**ADDENDUM NO. 2**

Date: August 31, 2018  
Project: **Secondary Treatment Plant Upgrade & Recycled Water Expansion**  
Job No.: 12600-07/16650-02

The following changes and/or clarifications are hereby made to the Contract Documents, and shall become a part of the Contract Documents dated July 2018.

**AERATION BASIN  
STRUCTURAL FLOOR PLAN**

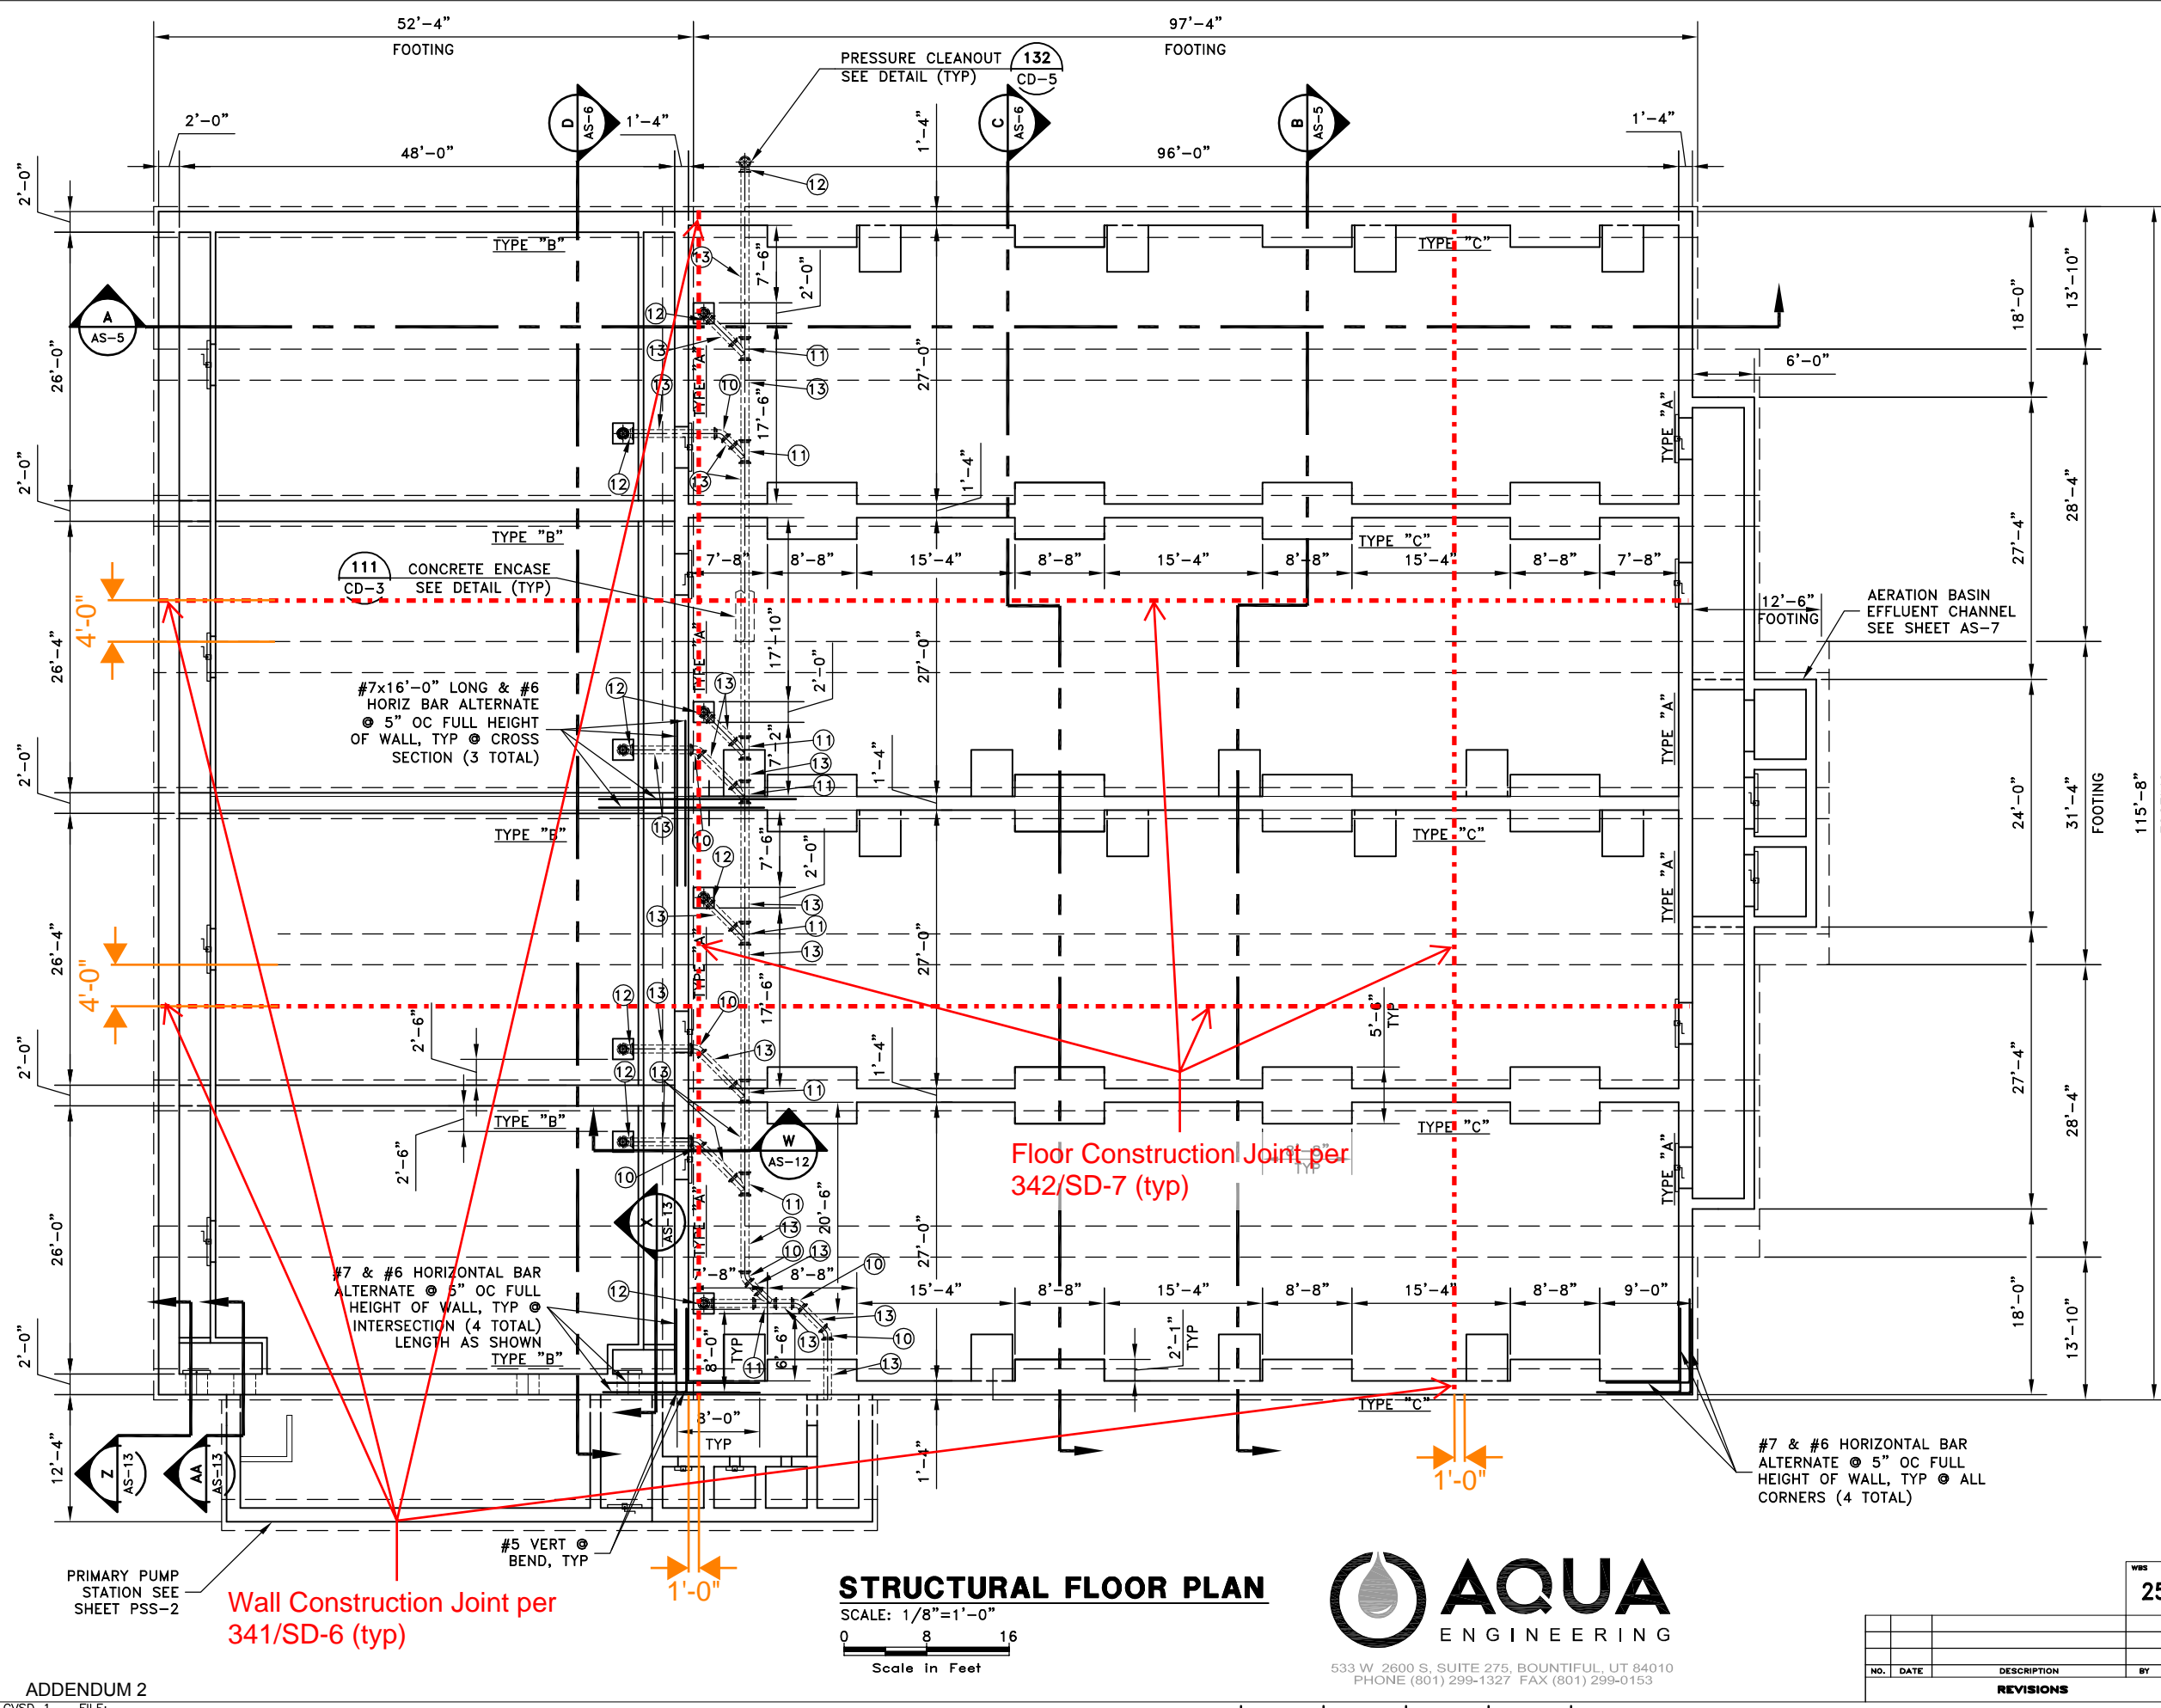
2. **Sheet AS-3:** The footing/floor slab and walls are mat foundation design and require construction joints. **A copy of this drawing indicating the required locations for construction joints is provided as an attachment to this addendum.** Note that the wall joints will be located inline with the floor joints as indicated in the drawing. Floor and wall construction joint details are already provided in Volume 4A, specifically detail 342 on sheet SD-7 and 341 on sheet SD-6.

1. Drawing AS-3 does not appear to indicate any construction joints in the Aeration Basin floor slab. Please confirm.

### UV BUILDING STRUCTURAL FLOOR PLAN

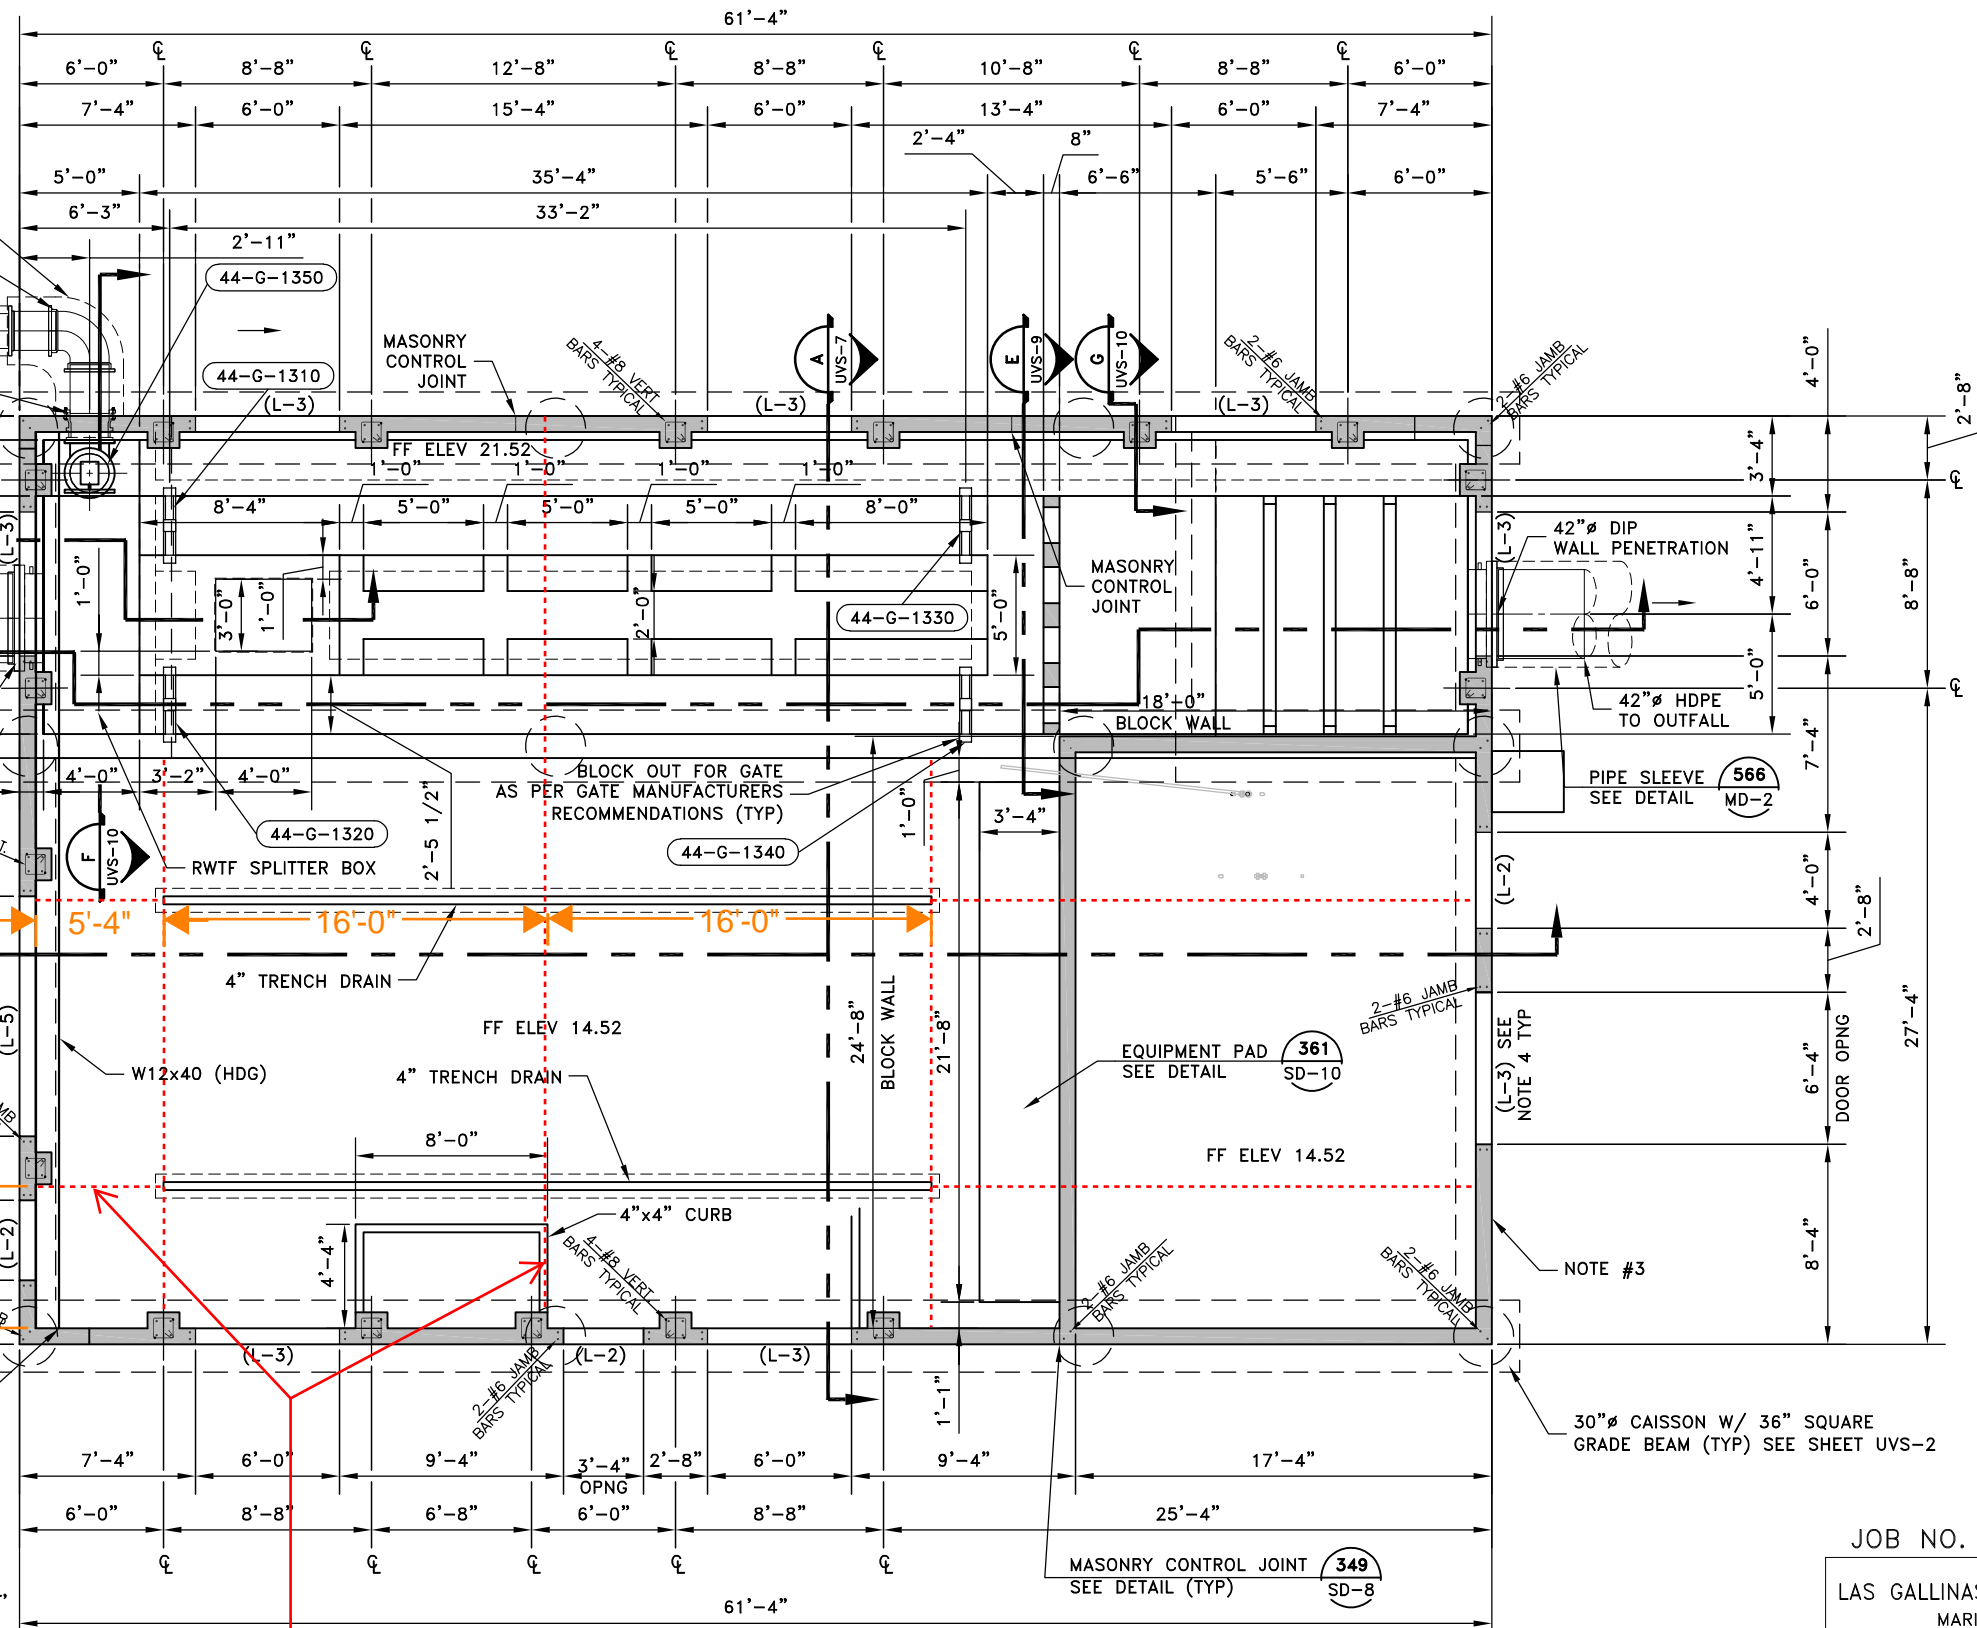
3. **Sheet UVS-1:** Construction joints are required for the UV building floor and channel. **A copy of sheet UVS-1 is provided with this addendum indicating the required locations.** Construction joints shall be per detail 341 on sheet SD-6.

4. Drawing UVS-1, Note 1, indicates to Place Control and Construction Joints as Shown on Plans. None appear to be indicated in the concrete work, except at wall to floor connections. Are these the only ones required? We are not supposed to add or take away any throughout the project.

**ELECTRICAL BUILDING  
STRUCTURAL PLAN**

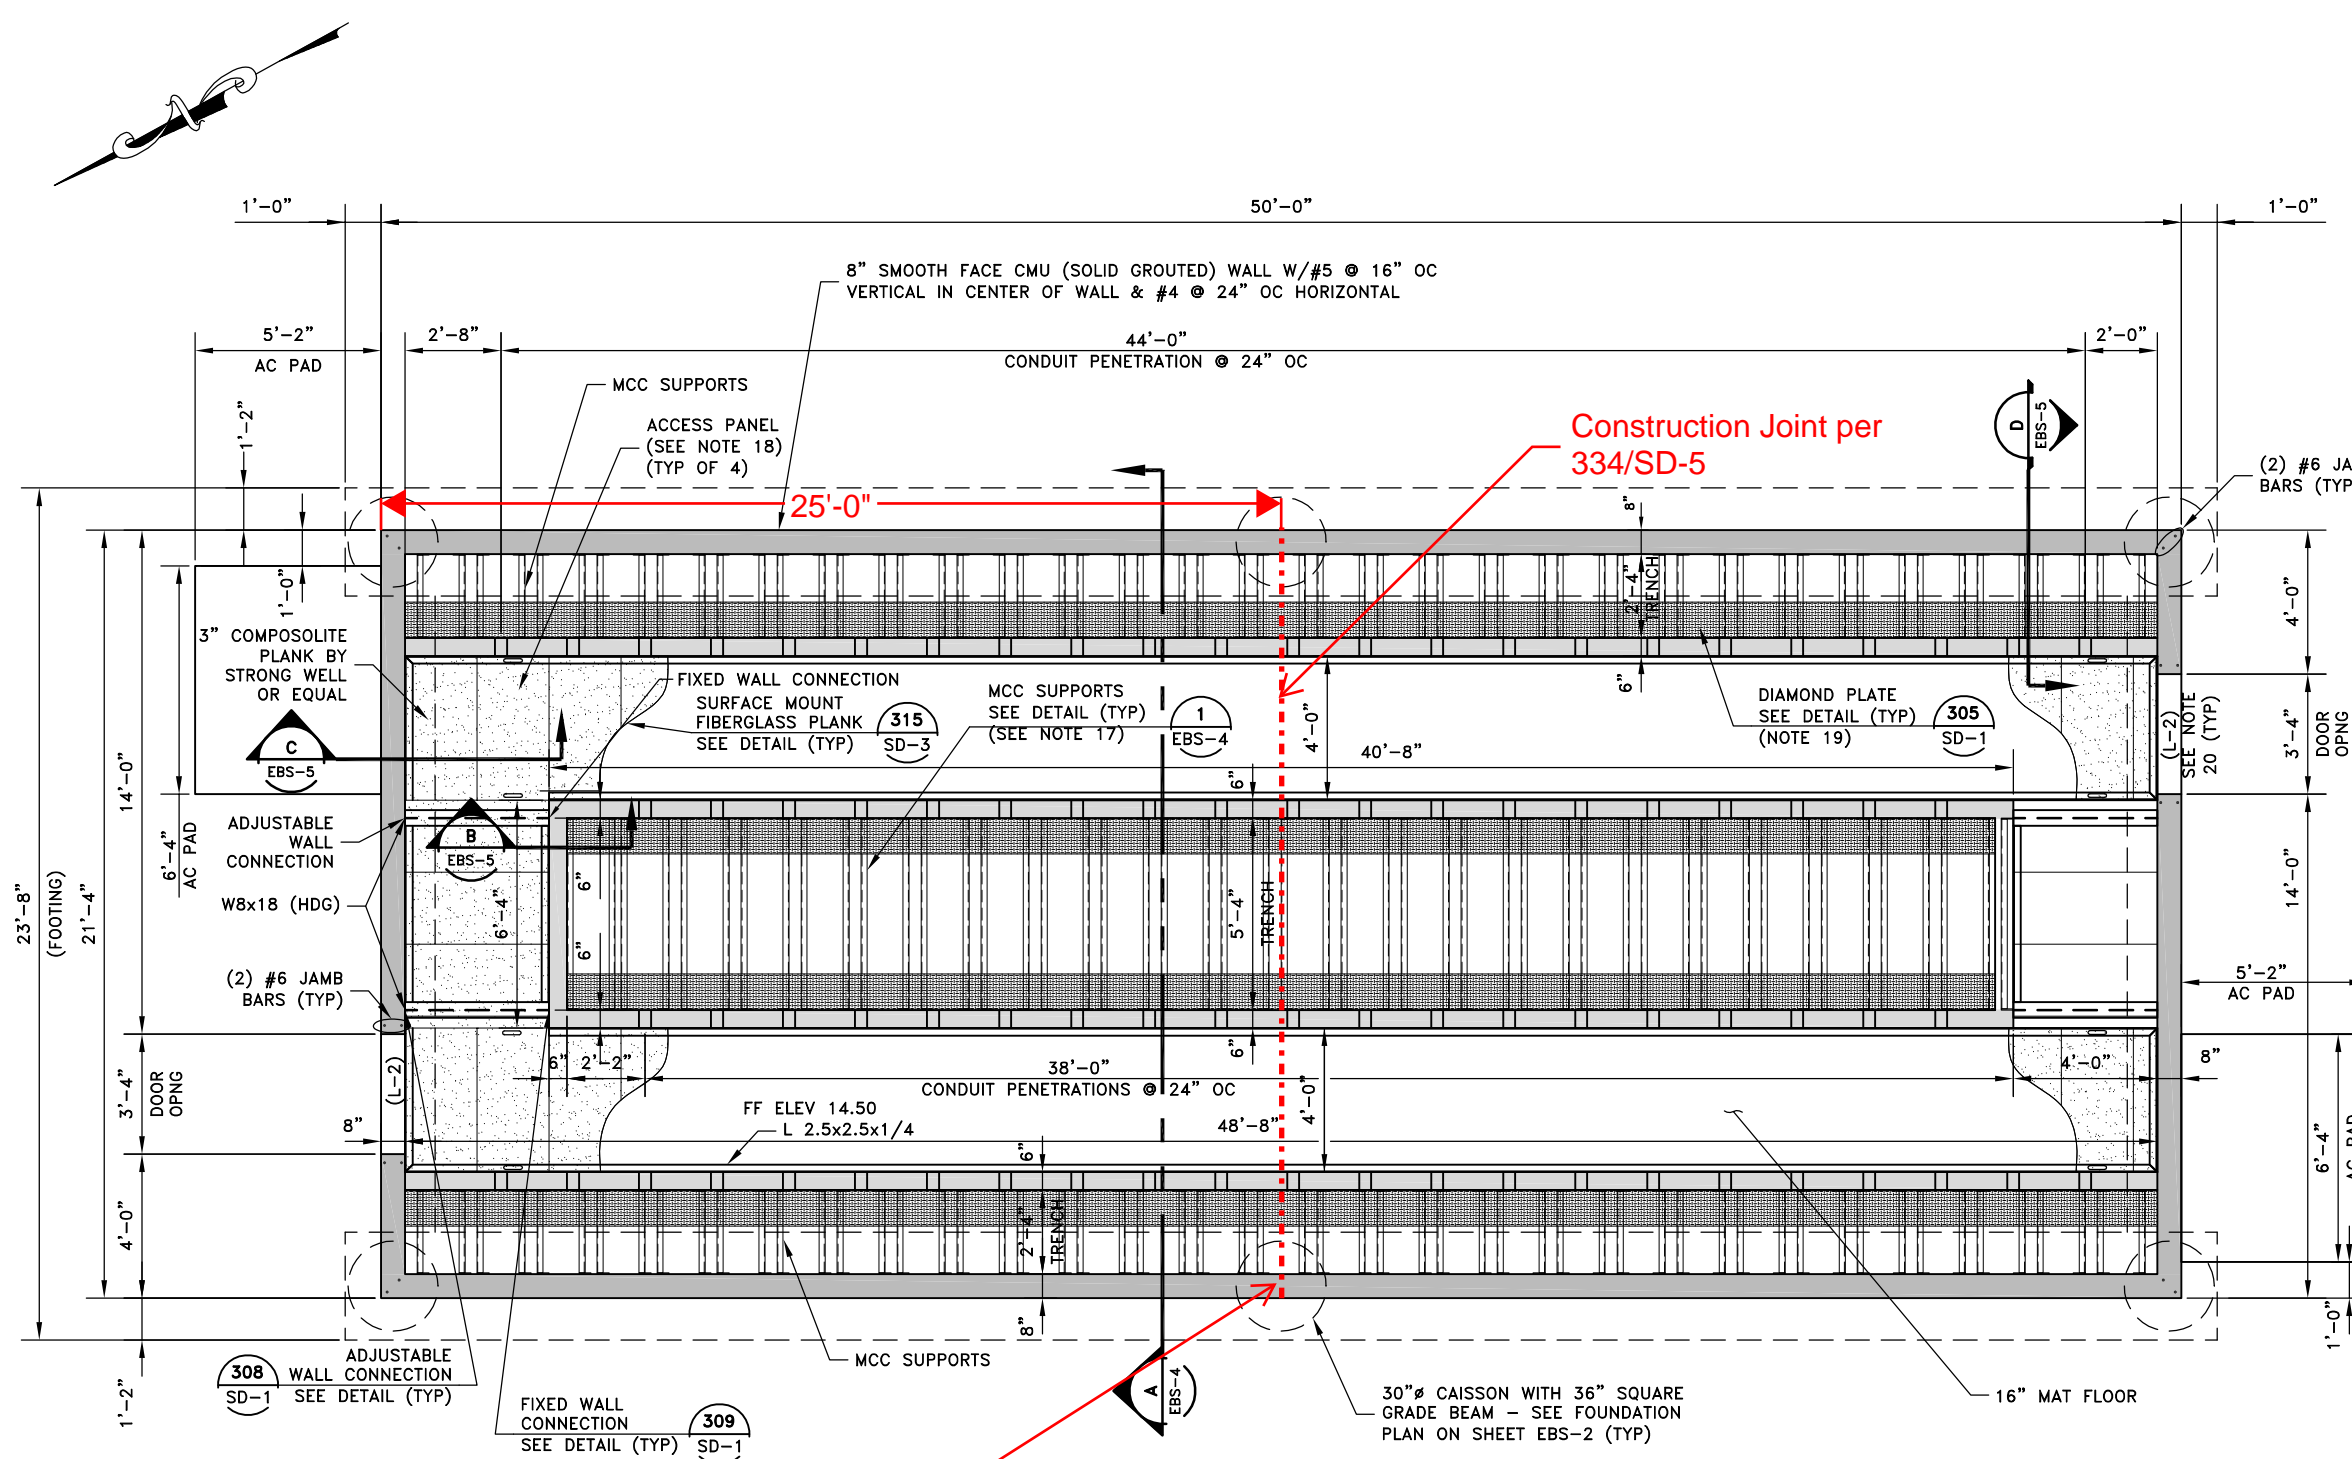
4. **Sheet EBS-1:** The structural engineer has added a construction joint in the center of this building to serve as crack control. **A copy of sheet EBS-1 is provided with this addendum indicating the required location.** The floor construction joints shall be per detail 334 on sheet SD-5, and the construction joint in the concrete stem wall shall be per detail 341 on sheet SD-6.

5. Drawing EBS-1, Note 10, indicates the contractor shall place control joints per detail 347/SD-8 so as to limit cracking. EBS-2, Note 4, says to pour the slab monolithically. Specification section 032900 3.3.C.1 says to make control joints at locations shown on the Drawings. Do not eliminate or relocate control joints. As none are shown, none will be added. This shall be the case for all joint types on all structures. Please add to all structures so they can be included in the bid cost.

**As discussed above in the comments for Volume 4A, the structural engineer has elected to add a construction joint to the center of the building to serve as a control joint. Refer to the copy of EBS-1 that is attached to this addendum.**
